**NOTICE OF ADDENDUM  
ADDENDUM NO. 2**

**CONTRACT NO. 9086  
Metro Transit Hanson Rd Bus Facility Remodel**

This addendum is issued to modify, explain or correct the original Drawings, Specifications, or Contract Documents marked as ***Metro Transit Hanson Rd Bus Facility Remodel, City of Madison Project 10950, Contract No. 9086, as issued on September 19, 2023, Addendum #1 as issued on September 28, 2023 and Addendum #2 as issued on October 17, 2023.*** The addenda are hereby made a part of the contract documents, represents clarifications of the previously released documents, consists of eleven (11) pages, and the referenced exhibits.

1 MAINTENANCE BUILDING - EAST ELEVATION  
SCALE: 1/16" = 1'-0"

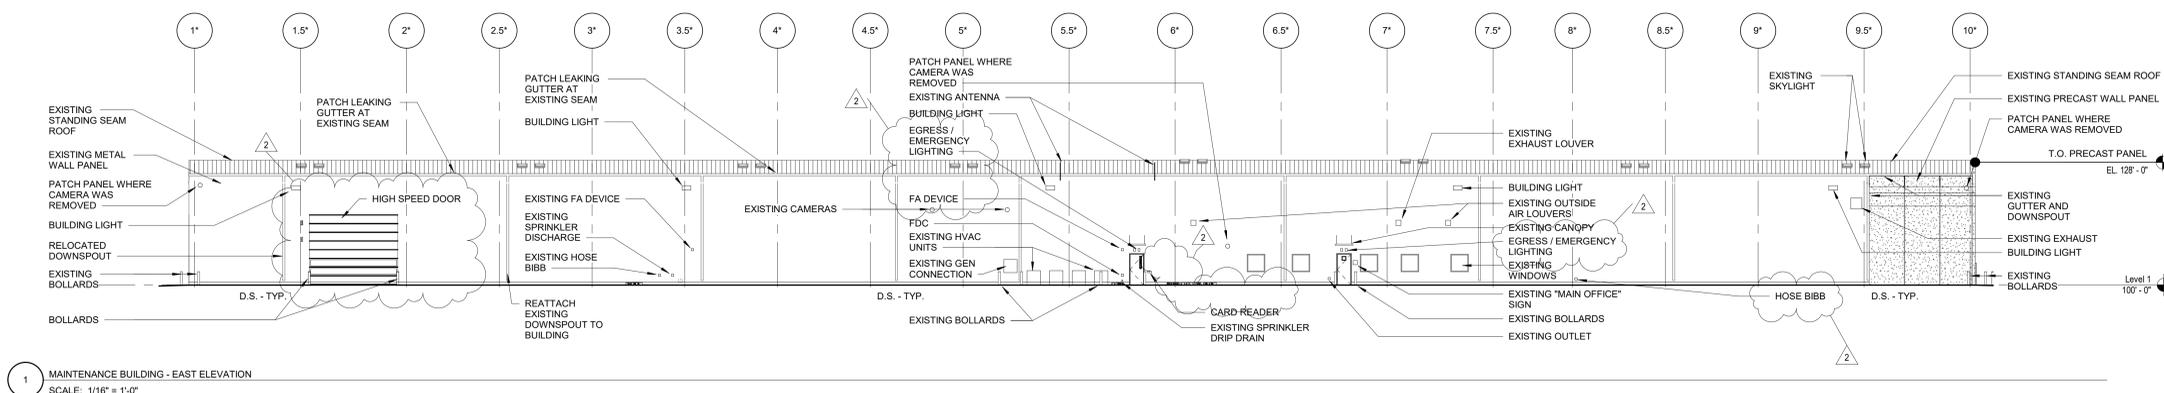
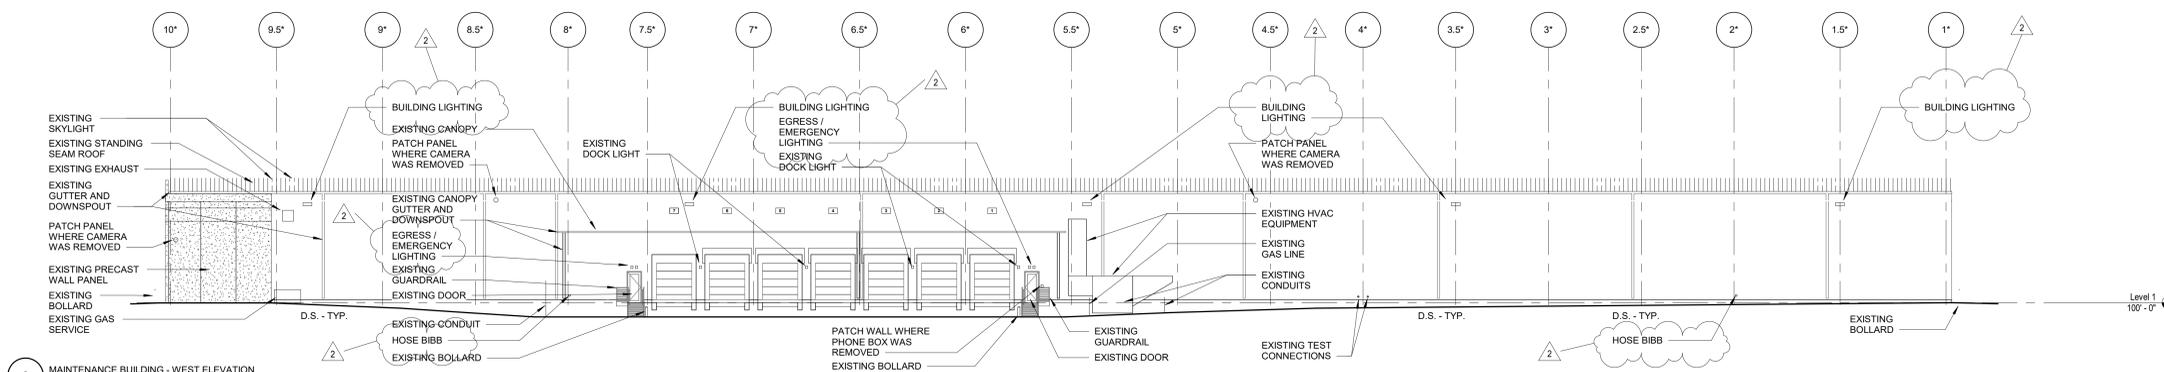
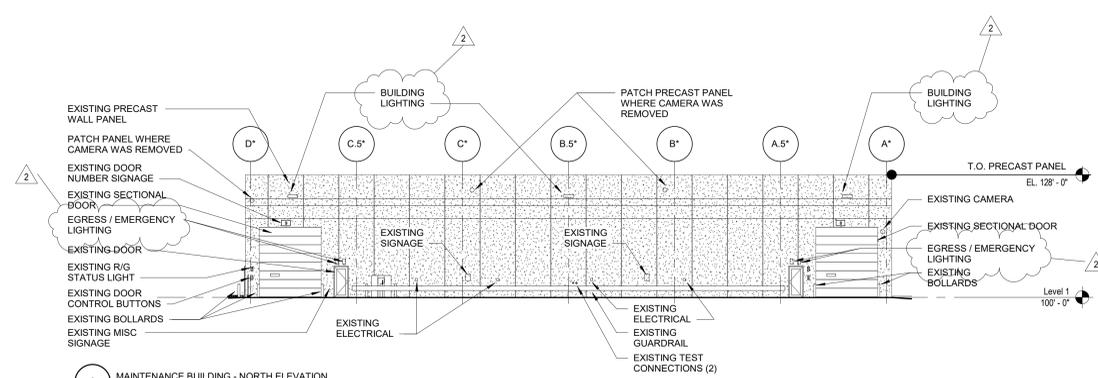
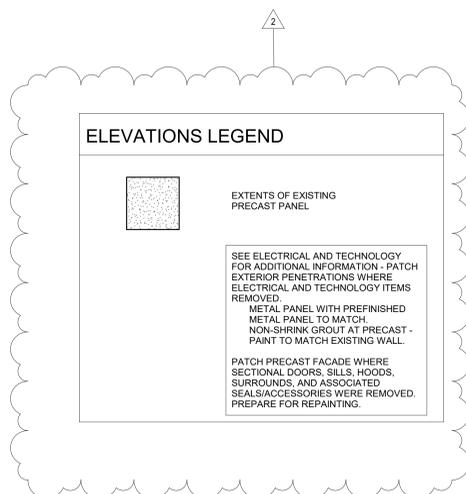
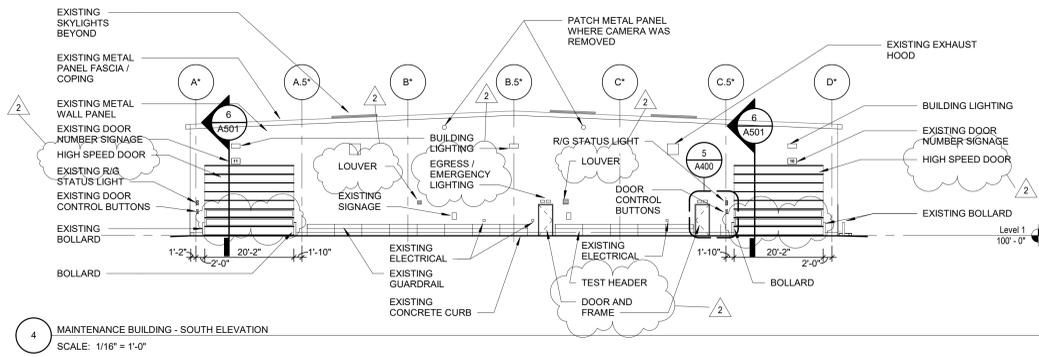
- B. Detail 2 – West elevation
    1. Revise note regarding egress / emergency lighting.
    2. Add note regarding building lighting.
    3. Add hose bibbs.

- C. Detail 3 – North elevation
    1. Revise note regarding egress / emergency lighting.
    2. Add note regarding building lighting.
  - D. Detail 4 – South elevation
